DRAWING AMENDMENTS

Atty Docket No. D-4031 Serial No.: 10/735,351

Amendment A

Fíg. 4

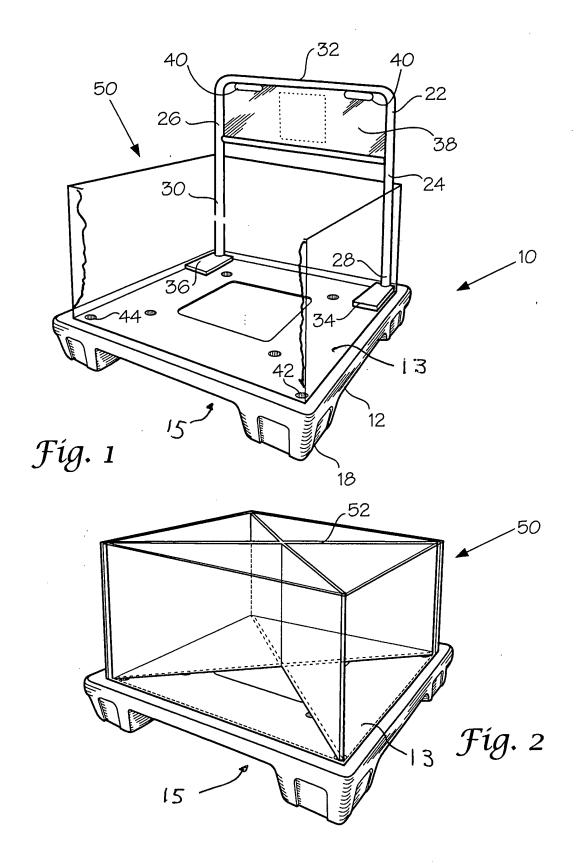
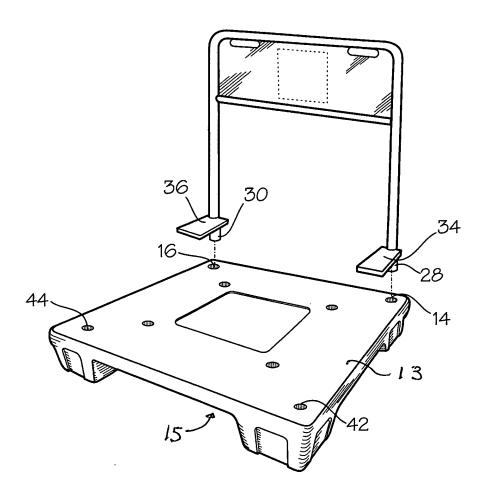
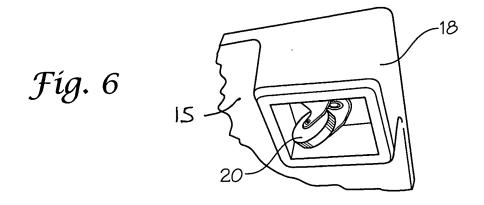
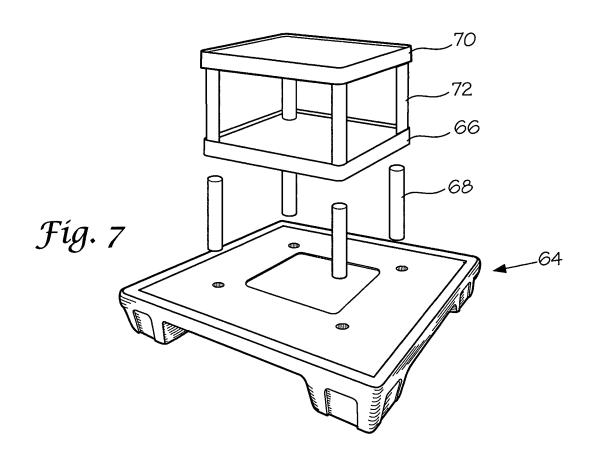
Please amend drawing FIGS. 1, 2, 4, and 6 as indicated in red ink on the three (3) marked-up drawing sheets following herein wherein reference numerals 13 and 15 are added as requested. No other changes are made to the drawings. Please enter the five (5) replacement sheets of formal drawings appended at the end of this amendment to replace the original five (5) sheets of drawings.

The drawings were objected to under 37 CFR § 1.83(a). The top and bottom surfaces of the pallet recited in the claims lack reference numbers in the drawings. Accordingly, reference numeral 13 has been added to indicate the top surface of the pallet and reference numeral 15 has been added to indicate the bottom surface of the pallet. No new matter has been added. The drawings are now believed to comply with the requirements of 37 CFR § 1.83(a).
